BRIDGE DESIGN MEMORANDUM

SUBJECT: **Design Memorandum 2017-01**
LRFD Design for Overhead Sign Structures, Structural Supports for CCTV cameras, RWIS, and Non-invasive Pavement Sensor Systems, and their Foundations
Straight Anchor Rods for Foundations

The Bureau of Bridge Design is updating the Bridge Design Manual. During this process, certain design decisions are being issued for immediate implementation. Consequently, the Bridge Design Manual and Traffic Detail Sheets have been modified as follows:

TRAFFIC SIGNAL MAST ARM FOUNDATION - TYPE 2

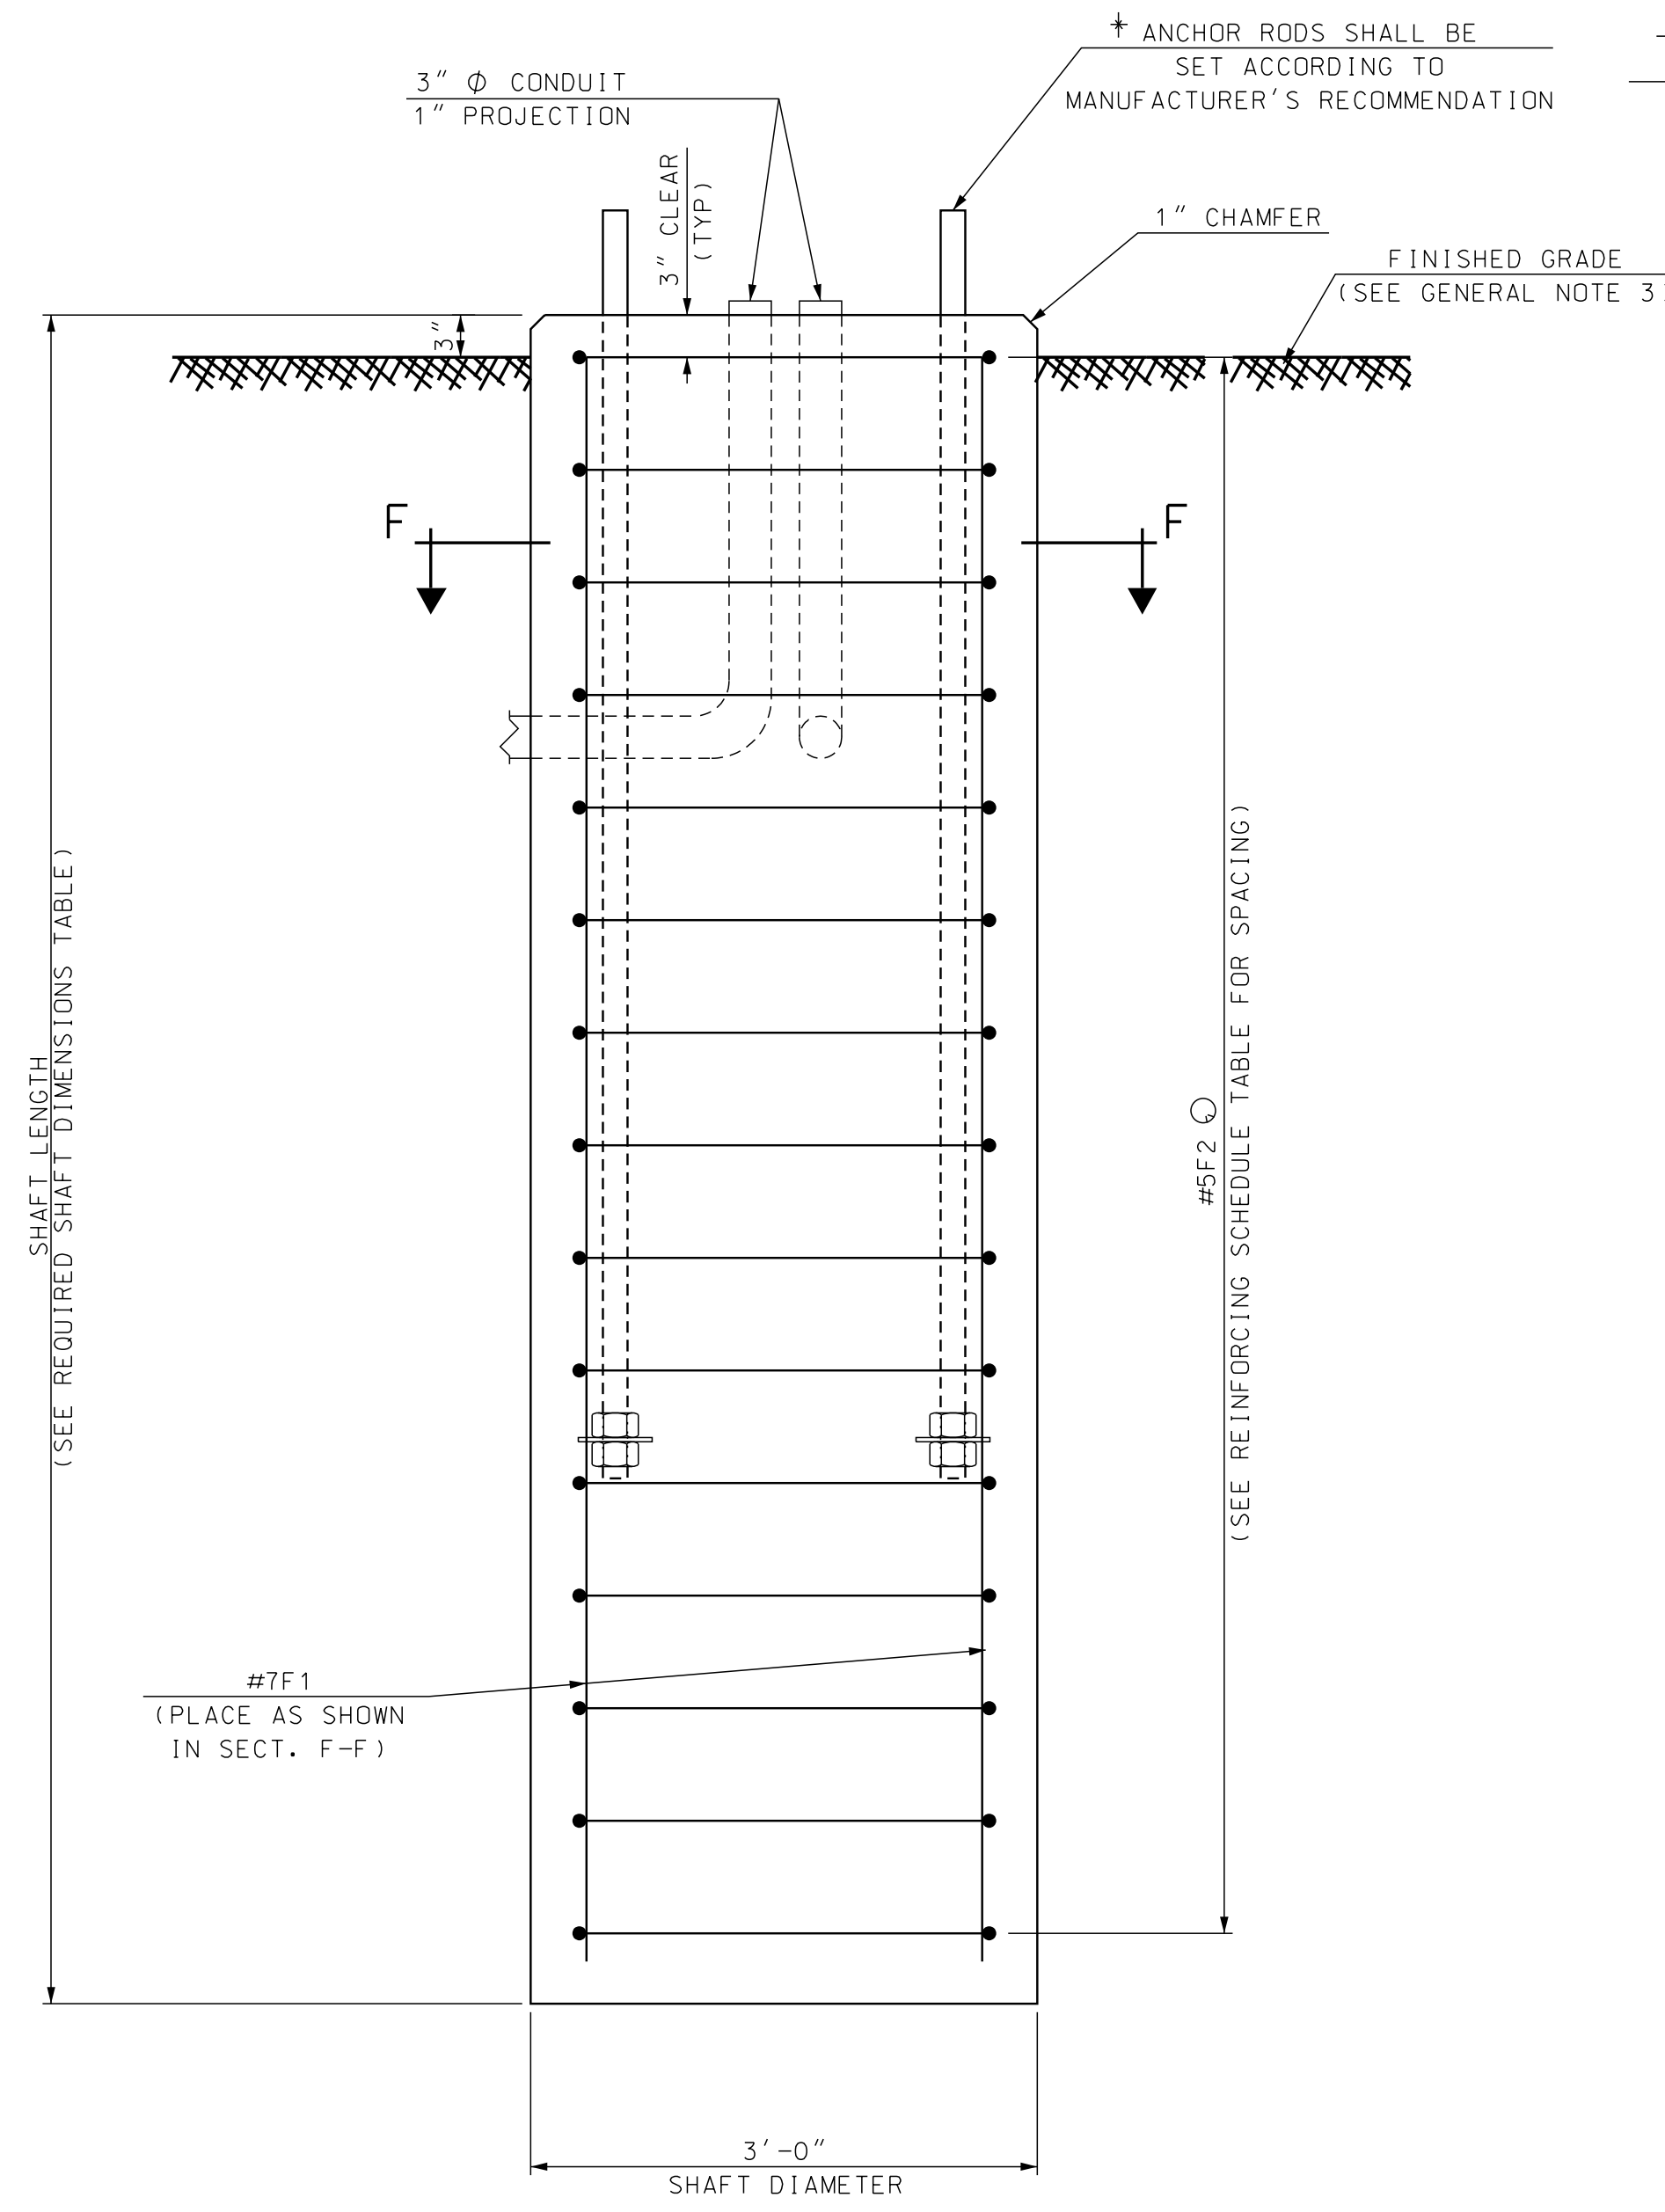
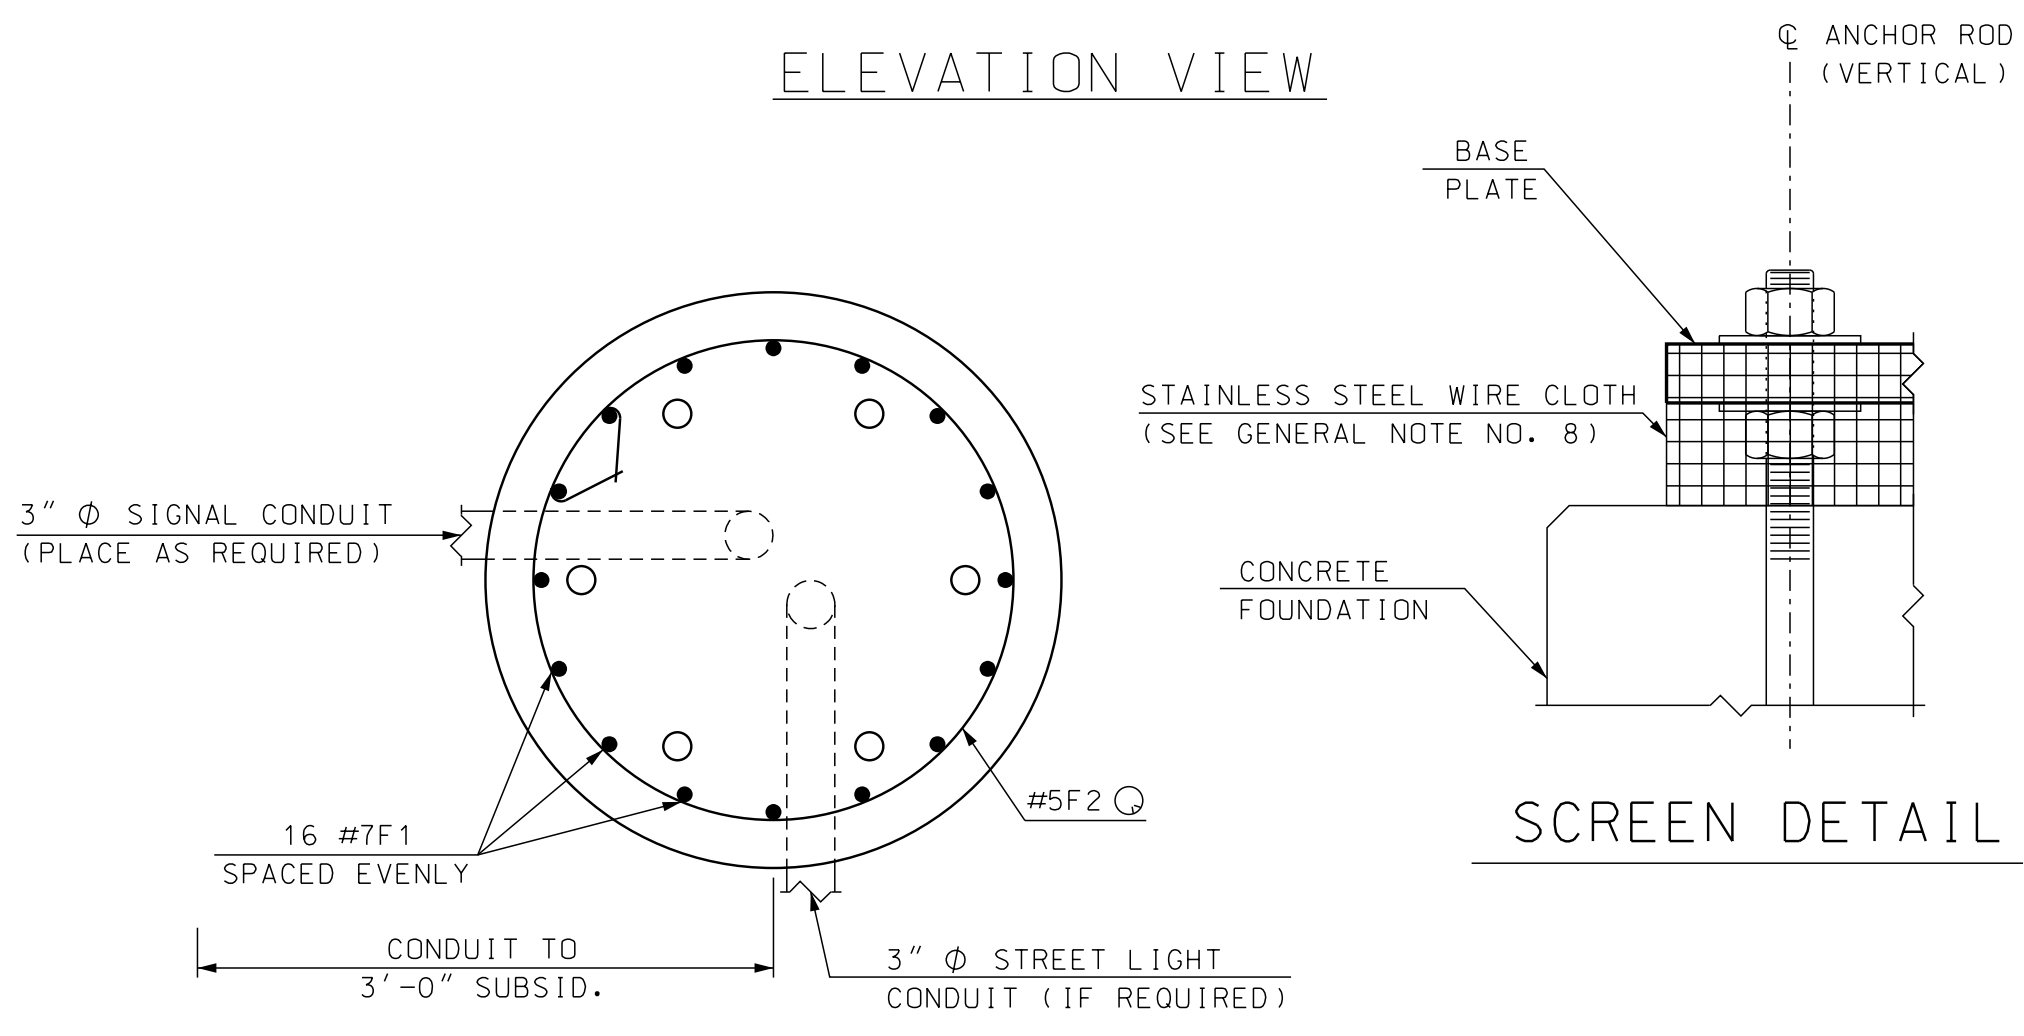
† ANCHOR RODS SHALL BE STRAIGHT RODS AND CONFORM TO ASTM F1554 GRADE 50 (MIN.). GALVANIZE THE ENTIRE ROD PER ASTM A153. EACH ANCHOR ROD SHALL BE SUPPLIED WITH A MINIMUM OF THREE HEX NUTS (ASTM A563 OR ASTM A194) AND A MINIMUM OF TWO FLAT HARDENED WASHERS (ASTM F436). LOCK WASHERS SHALL NOT BE USED. THE EMBEDDED END OF THE ANCHOR ROD SHALL HAVE EITHER ONE NUT TACKED WELDED OR DOUBLE NUTS. BENT (HOOKED OR J-BOLT) ANCHOR RODS SHALL NOT BE USED.
